December 13, 2019

**Addendum No. 02
TO THE CONTRACT DOCUMENTS FOR:**

MANSFIELD FIRE STATION NO. 4

KAI Project No. 2016.166

1 ENLARGED PATIO
A0.02 1/4" = 1'-0"

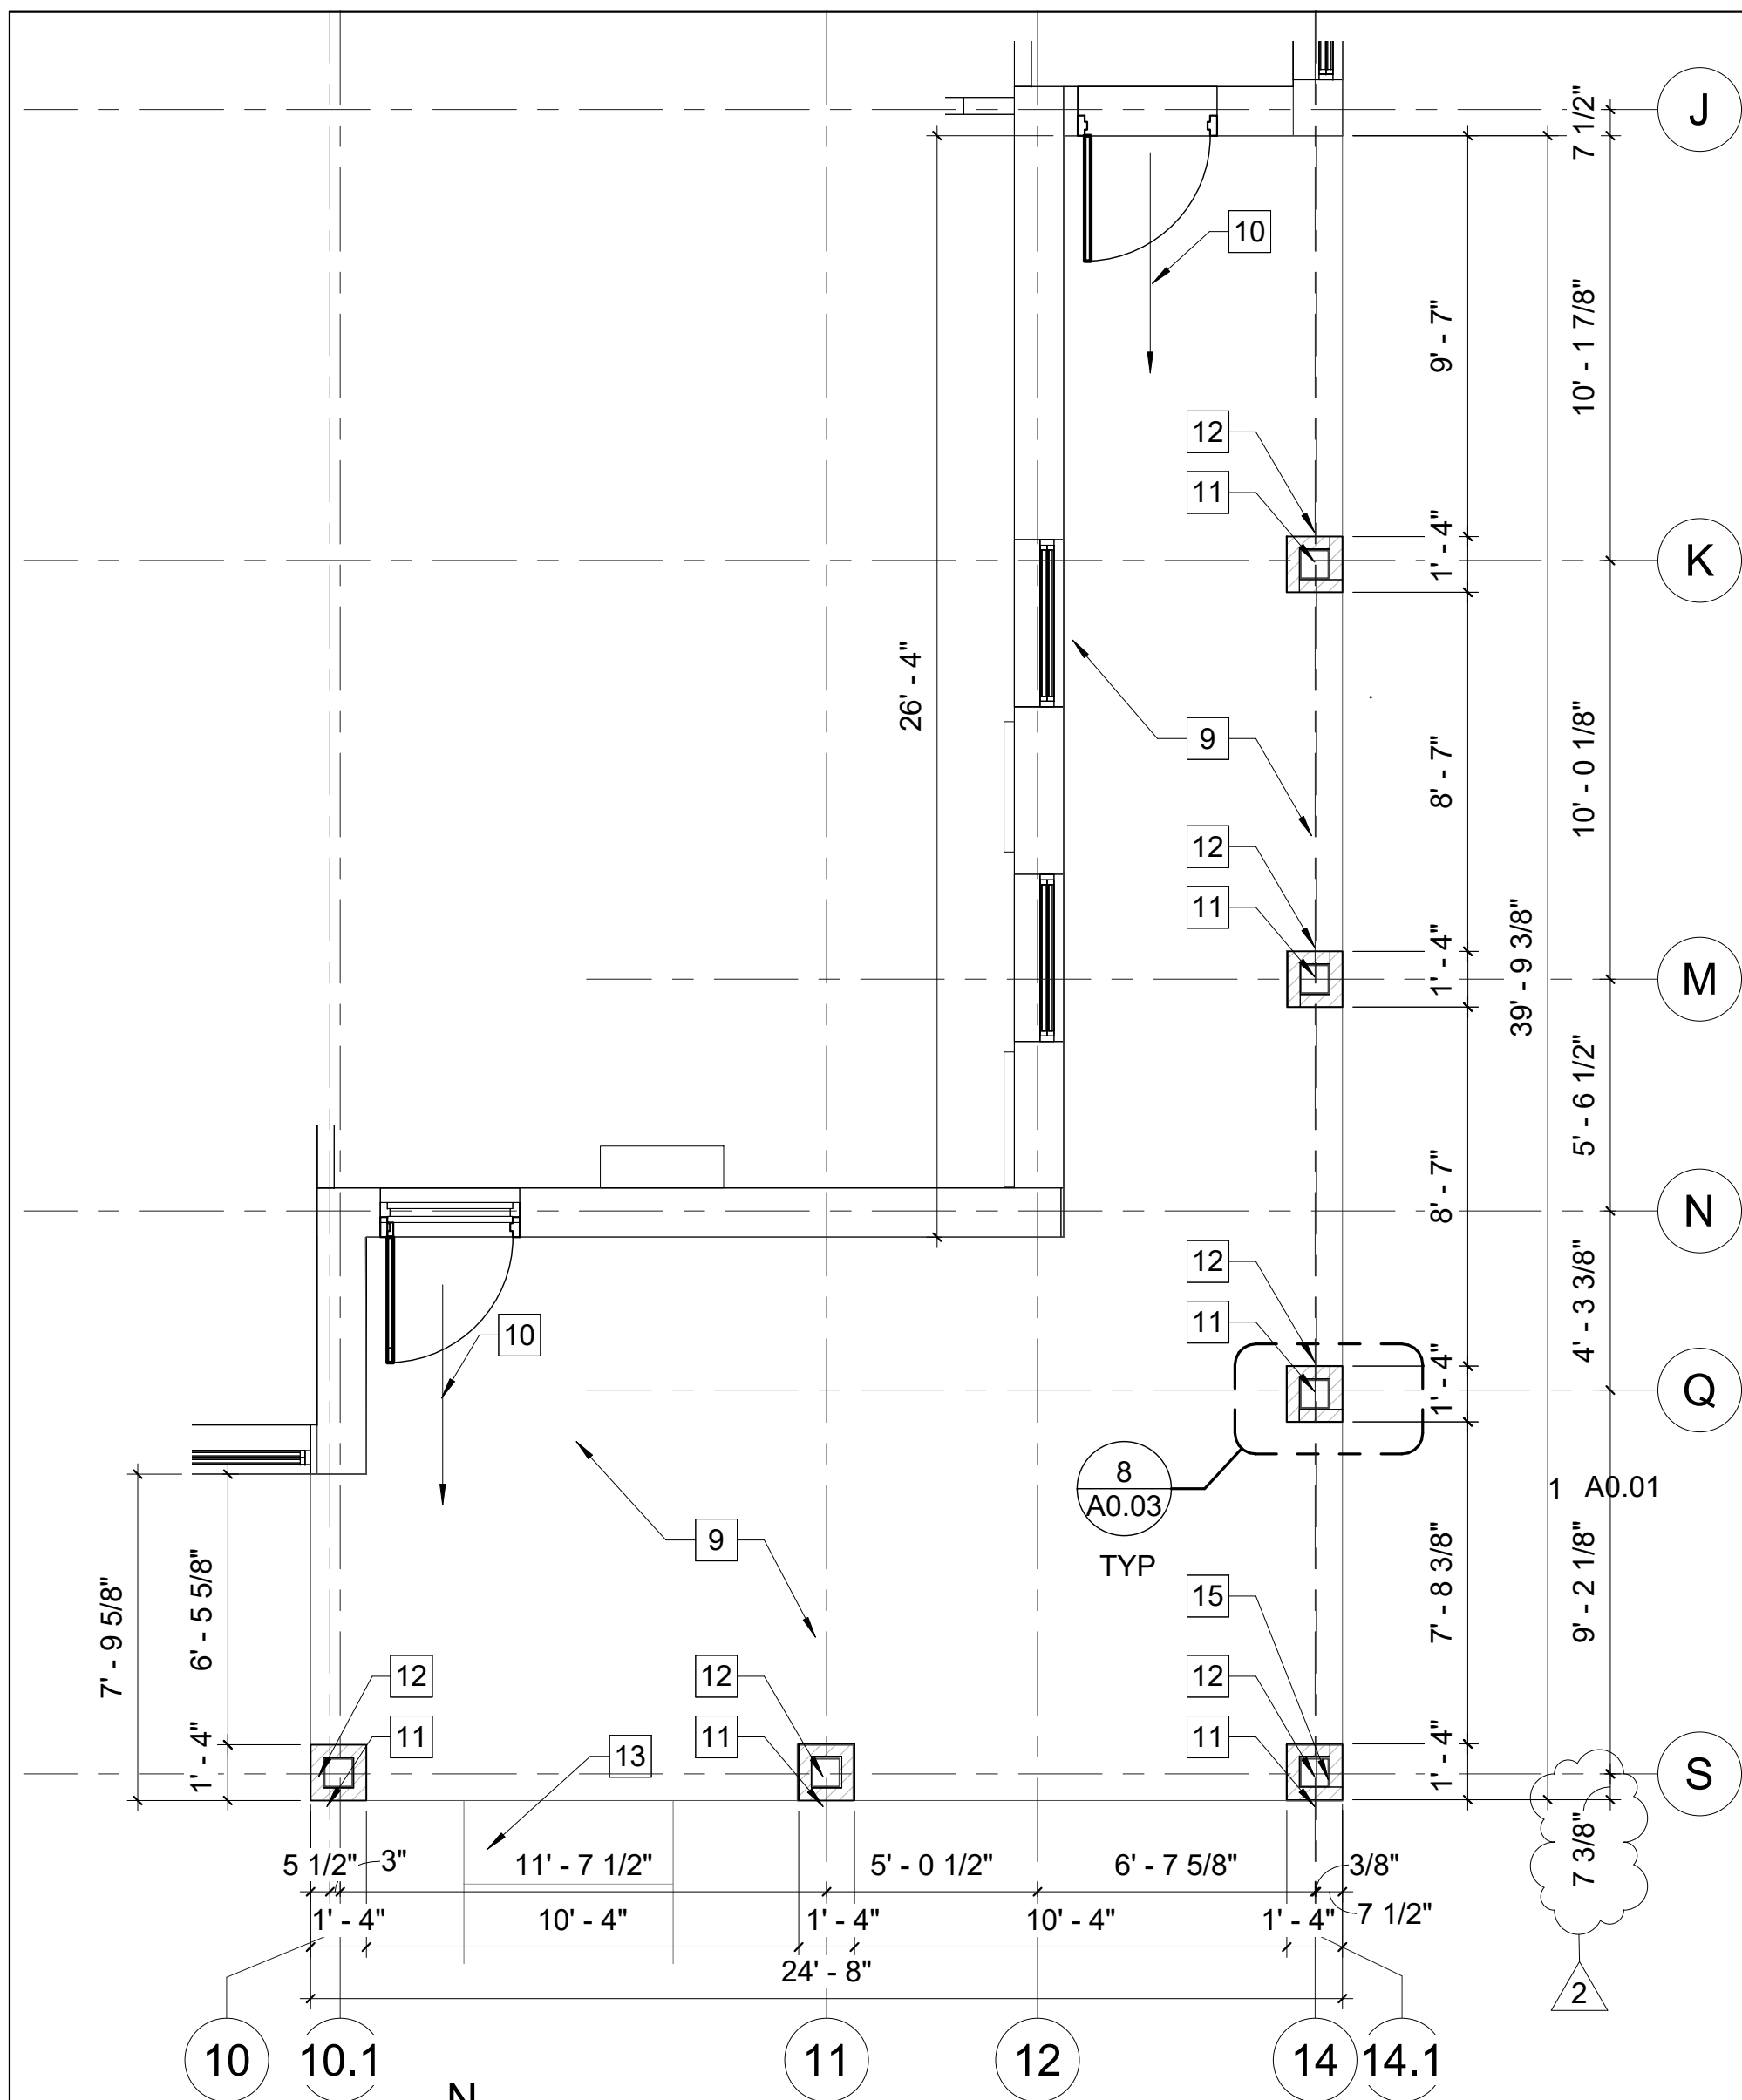
1. Sheet C5.0 – Revised sewer line.
2. Sheet C6.0 – Revised Gas and Fire line alignment.
3. Sheet A0.01 – See revised sheet to show drive revision to Holland Lane
4. Sheet A0.02 – See revised sheet for added dimension to 1/A0.02.
5. Sheet A1.01 – Added note 30.
6. Sheet A1.02 – Plan 2 – Clarified canopy dimensions and drainage. Added Note 7.
7. Sheet A4.06 – Detail 7 – Clarified Canopy fascia curb for canopy drainage.
8. Sheet A5.02 – Plan 2 – Revised size of Kitchen Island.
9. Sheet A5.03 - Omit B6 type accessory from project.
10. Sheet A5.06 – Elevation 12 and 17 – Revised width per island change.
11. Sheet S2.10 – Plan 1 – Revised grade beam in Bay. SLAB SCHEDULE – Revised bar sizes.
12. Sheet M0.02 – MULTI-ZONE DX SPLIT SCHEDULE revised.
